PLANT DATA BOOK ENTRY SUBMITTAL SHEET

TITLE: CORE OPERATING LIMITS REPORT FOR THE PERRY NUCLEAR POWER PLANT,
UNIT 1 CYCLE 6 (RELOAD 5)

PDB - F0001 /Rev. 3 EFFECTIVE DATE: 3-22-96

SCOPE OF CHANGE: Incorporate new fuel type information for Cycle 6
including MCPR limits which are fuel type dependent
and delta T dependent.

Flow Dependent MCPR Limit ($MCPR_f$)
Fuel Type GE11

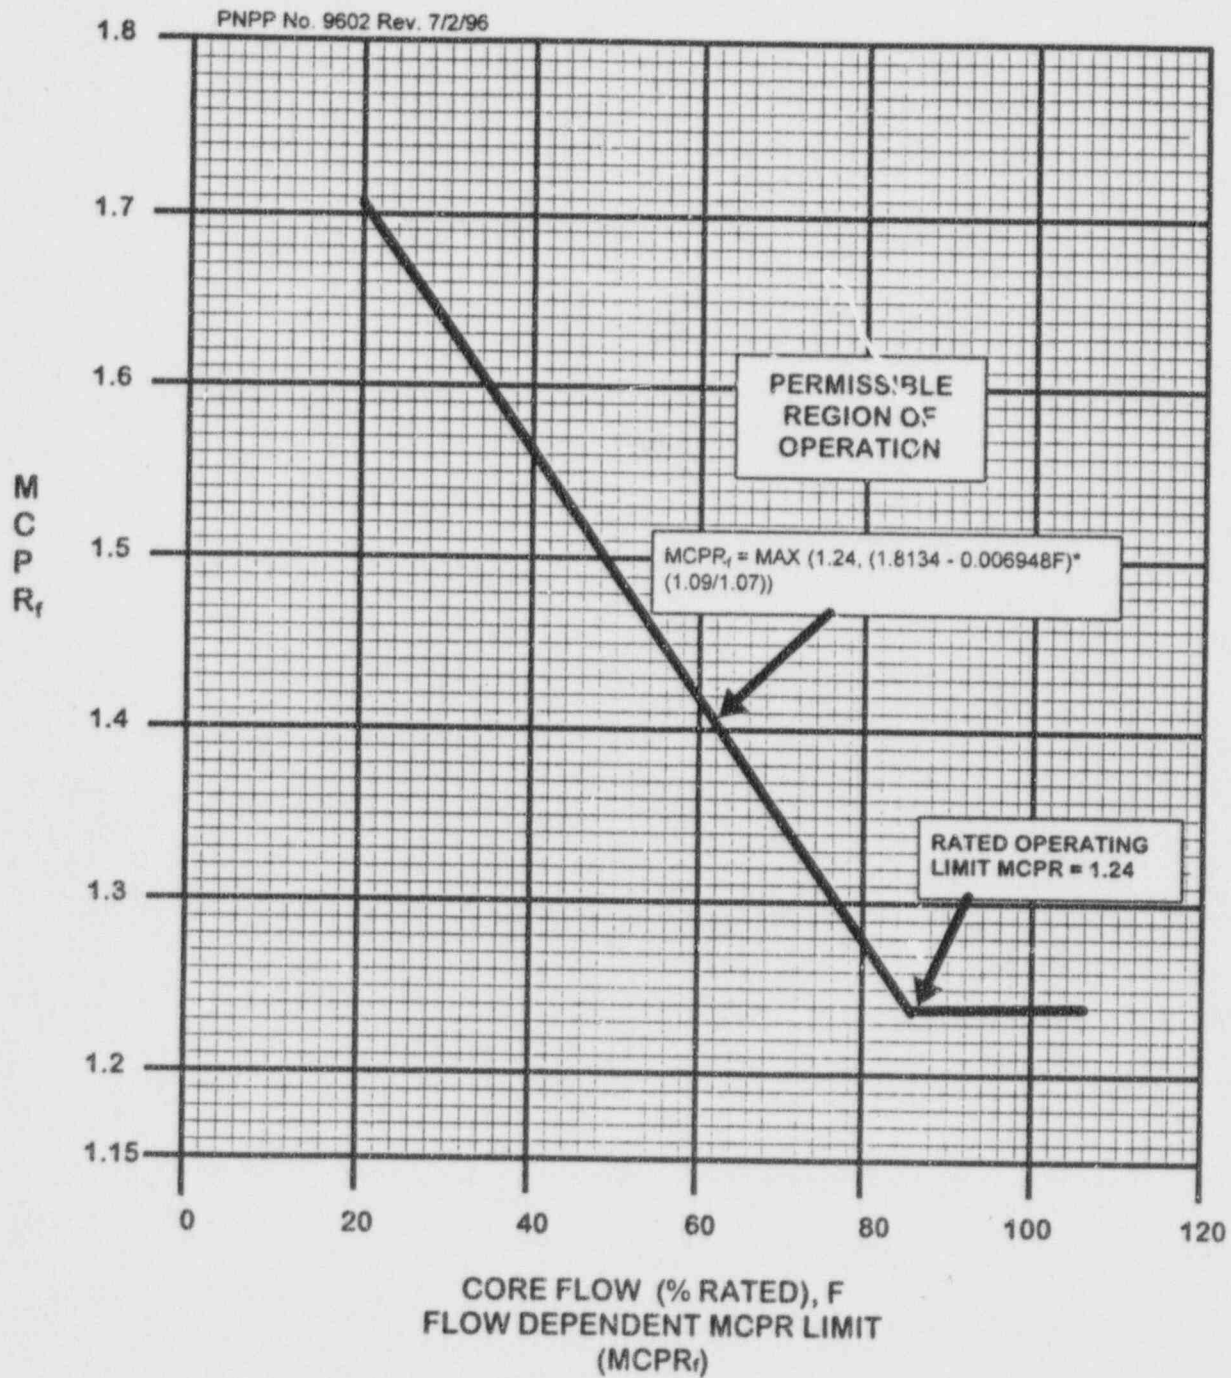
1. The MCPR curves were changed to compensate for the non-conservatism of the generic MCPR Safety Limit.
 2. In the references section, the reference "Supplemental Reload Licensing Report for Cycle 6" was changed to Rev 1 (June 1996).
-

Figure 3.2.2-4
Includes Fuel Loading Error results.

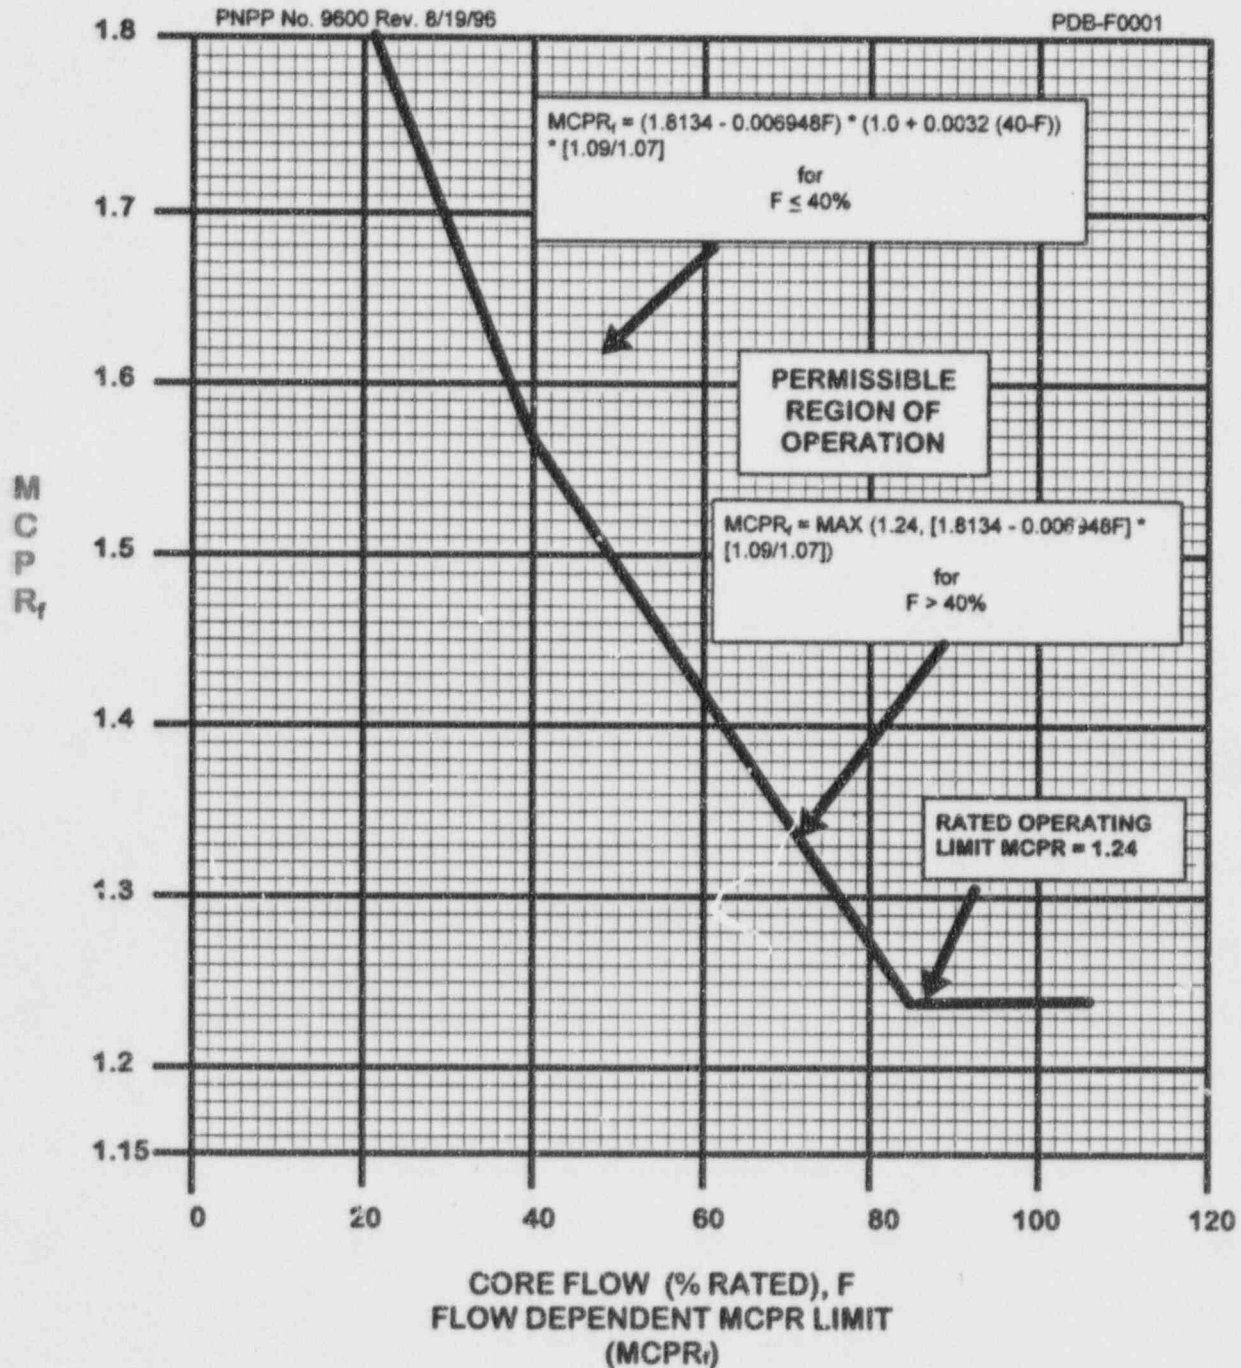
1. The equation which labeled the flow dependent MCPR curve contained a typo. There was no change to the actual curve.
-
